Project:	PROPOSED POOL, SPA & ALFRESCO
Client:	CANN
Site:	35 KEEL RETREAT, PORT GEOGRAPHE

Sheet title	**FLOOR PLAN**
Date	21 Oct 2026
Revision	A
Scale	1:100

A3-01

FLOOR PLAN

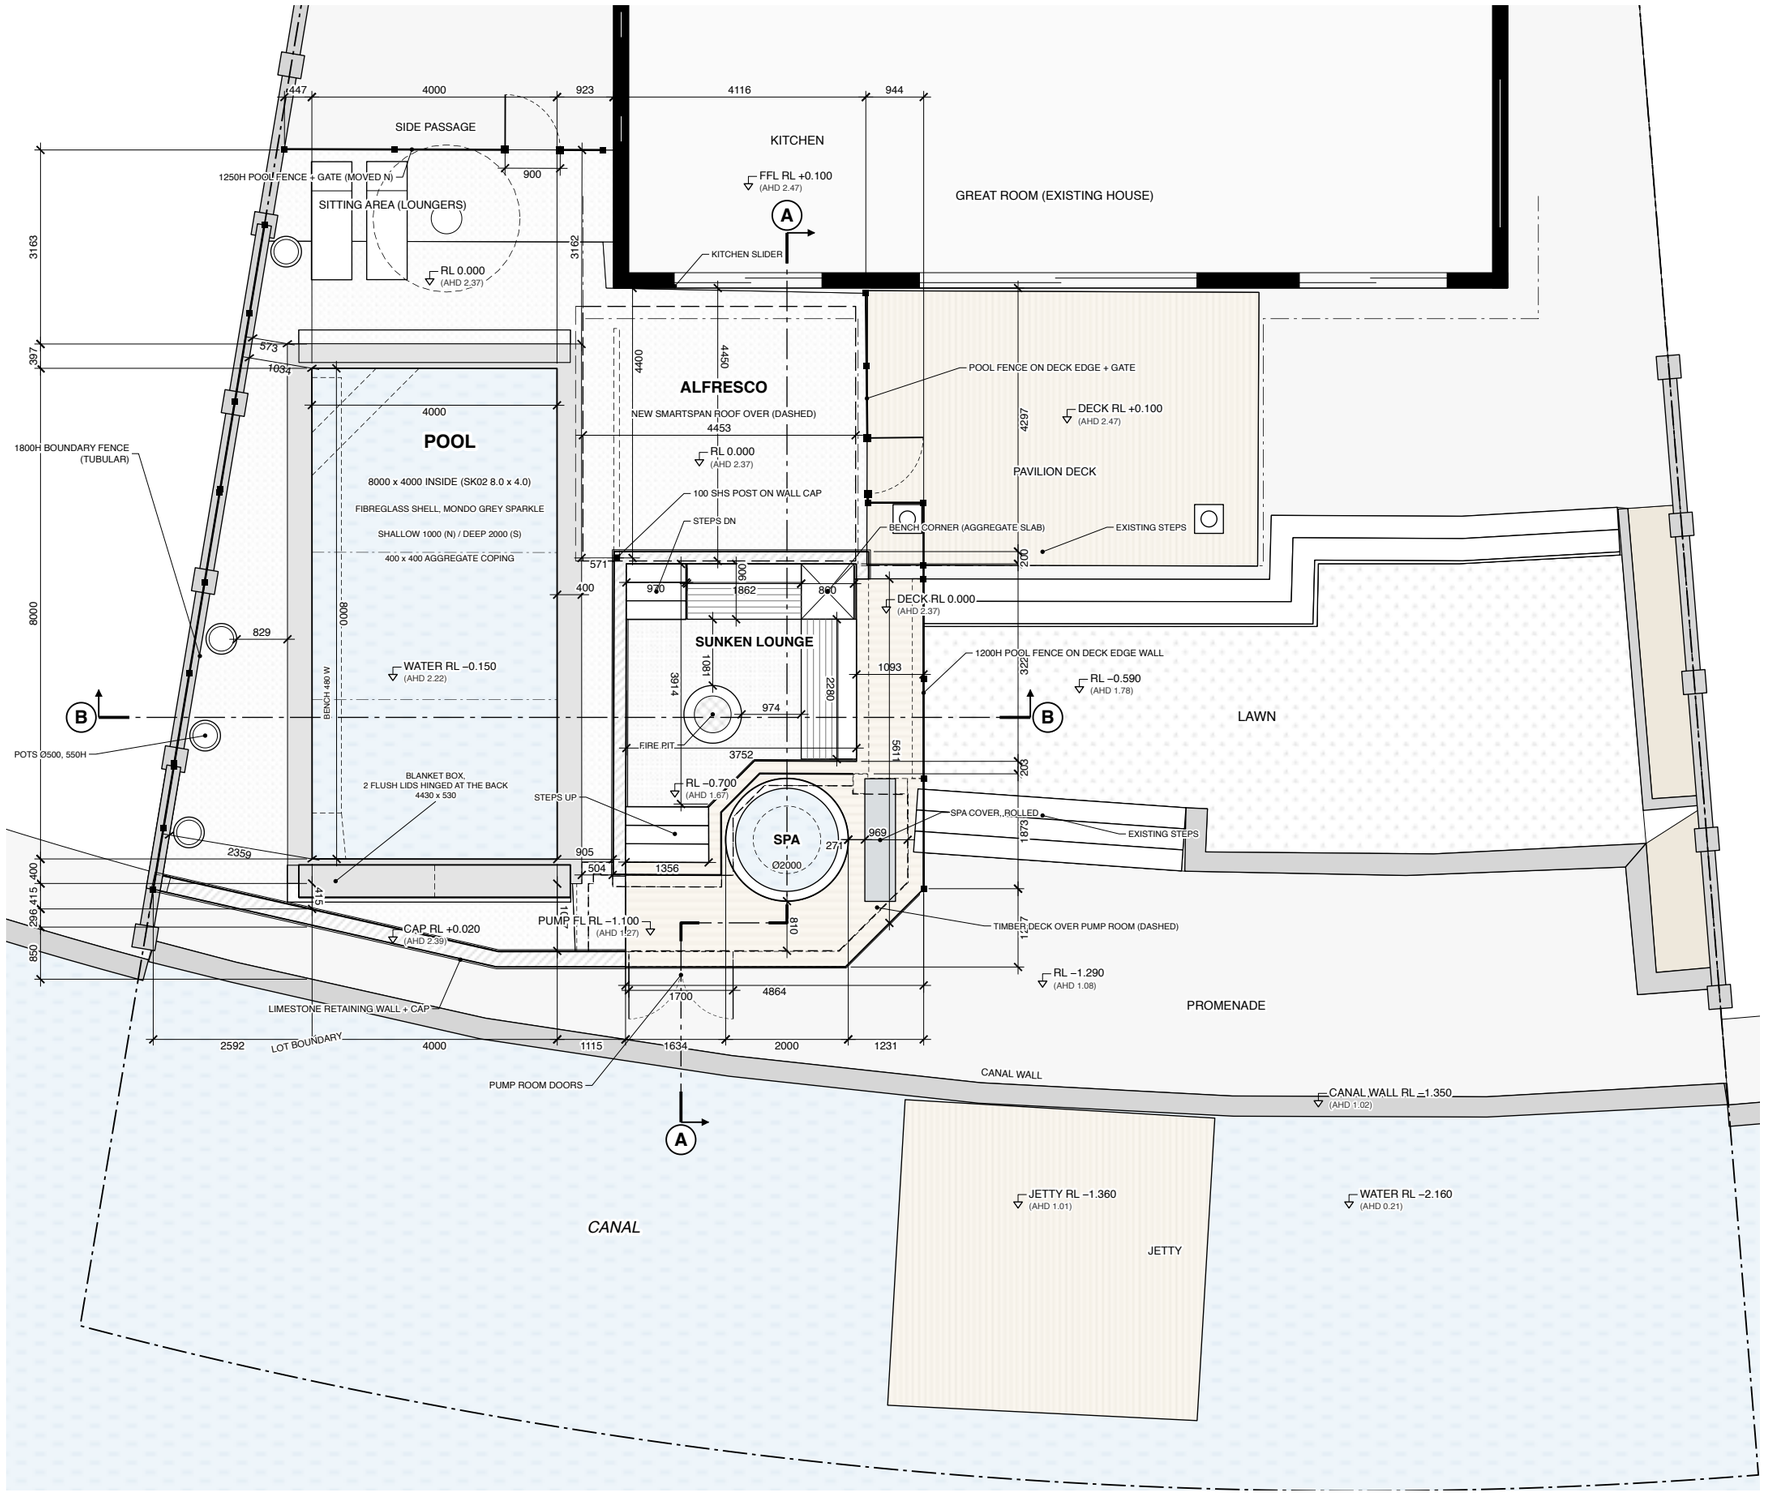
TO CONFIRM WITH BOB

- B5 over the pots: 1800 above the paving, but the 550H pots stand about 170 off its pool side, so about 1250 above a pot. OK, or move them clear?
- B3 at its north end: only about 1440 above the existing lawn steps against it. OK as is?
- Pump room doors in B4, the canal-side barrier wall: their outside face must be non-climbable. Which door and finish?
- B1 and B3 stop 170 and 90 short of the house wall: close them up.
